1994 No. 454

Traffic Signs (Amendment No. 2) Regulations (Northern Ireland) 1994

Made	*21st November 1994*
Coming into operation . .	*2nd January 1995*

640.2A

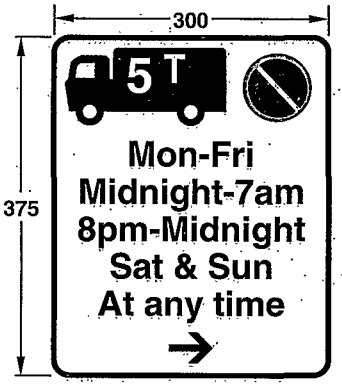
(ix) inserting in place of diagram 640.2 the following diagram and the words specified in or under it and the new number ascribed to that diagram;

Plate showing hours during and direction in which waiting by goods vehicles over 5 or 7.5 tonnes maximum gross weight is prohibited except for loading and unloading

Permitted variants: "7.5" may be substituted for "5" on the goods vehicle symbol. The days and times and the direction of the arrow may be changed to accord with the circumstances

640.3

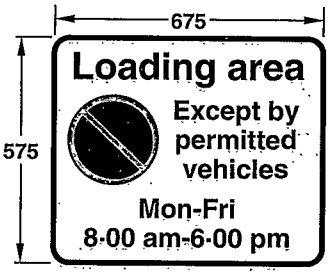
(x) inserting after diagram 640.2A the following diagrams and the words specified in or under them;

Entrance to a designated loading area in which waiting except by permitted vehicles is prohibited during the hours shown

Permitted variants: The days and times may be changed to accord with the circumstances

640.4

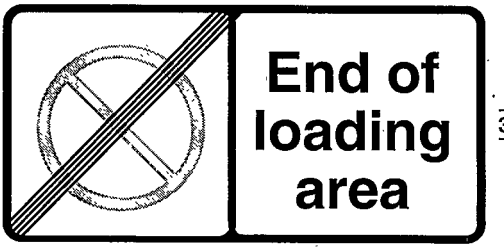
Sign showing hours during which waiting except by permitted vehicles is prohibited in a designated loading area

Permitted variants: The days and times may be changed to accord with the circumstances
